WP-8x4x Release Notes

Hardware Revision:

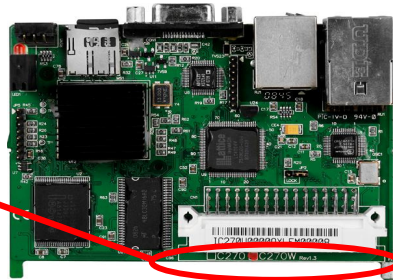
As the Intel 95ns and 75ns J3 Flash chip has been phased out, the chip in the WP-8x4x has been replaced with a 105ns version. However the new J3 Flash chip is not 100% compatible with the original one. Thus the OS and Eboot software for the WP-8x4x must be updated to version 1.5.0.1 (or later of the OS) and 1.2.0.1 (or later of the Eboot) to support both versions of the Flash chip. Version 1.5.0.2 fixes the problem that the 75ns J3 Flash chip is not able to run on OS version 1.5.0.1.

Also please note, older versions of the OS and Eboot software will not work on WP-8x4x modules that are equipped with the new J3 Flash chips, so earlier version of the OS and Eboot software should not be installed as the module will not boot.

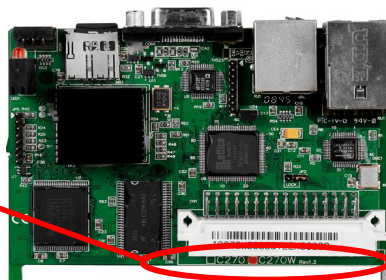
Intel 的 95ns 與 75ns J3 Flash Chip 已經停產，WP-8x4x 從 2010 年 4 月 6 日起，將使用另一個 105 ns 的 J3 Flash Chip 進行取代。但是這個新的 J3 Flash Chip 和原來的並不是 100% 相容，因此，必需將 OS 及 Eboot 更新到 1.5.0.1 及 1.2.0.1 版，以同時支援這兩種 J3 Flash Chip。1.5.0.2 版 OS 新增支援 75ns Flash Chip。

但是必需注意的是，舊版的 OS (1.4.2.1)及 Eboot (1.0.6.1)在配備新版 J3 Flash Chip 的 WP-8x4x 上將無法正常運作。請勿將舊版 Eboot 及 OS 安裝到配備新的 J3 Flash Chip 的 WP-8x4x 上，以免造成無法開機的問題。
